REVISED HERITAGE IMPACT ASSESSMENT & CONSERVATION PLAN FOR 211-231 BANK

Applications D02-02-22-0127 / D07-12-22-0188 and plan number 18910

Revision 2: October 2024

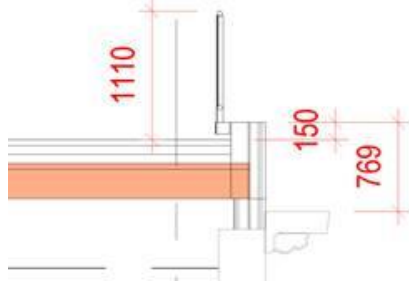
Heritage Application 219-223 Bank Street, at 178 Nepean Thank you for your submission, heritage staff are pleased to see the response to our comments and the detailed engineering study of each façade. Comments regarding the design:

Response:

The upper floors were intended to provide background vanilla and help focus on the podium and pedestrian scale of Bank Street. The planned Richcraft highrise towers adjacent to the site will overwhelm the nine storey and the distinction will further emphasis the foreground.

This could be a red/brown or black accent colour that relates to the existing brick or cornice colour. This will help to integrate the new construction better to the Centretown HCD.

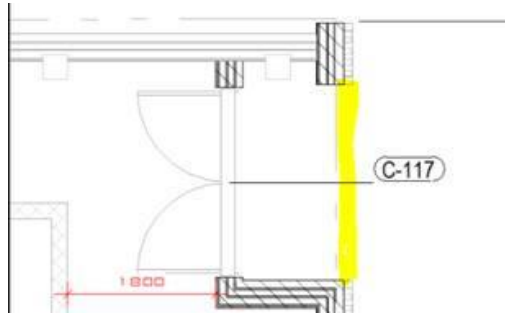
- Recess the Lisgar entrance to maintain the character of the carriageway. This feature was identified as a heritage attribute in the Conservation Plan and there are few left in the HCD, so should be respected.

Response:

The doors have been set back but with the need for security and these alcoves being used for sleeping, would a metal grid used at night be acceptable (yellow highlight below)?
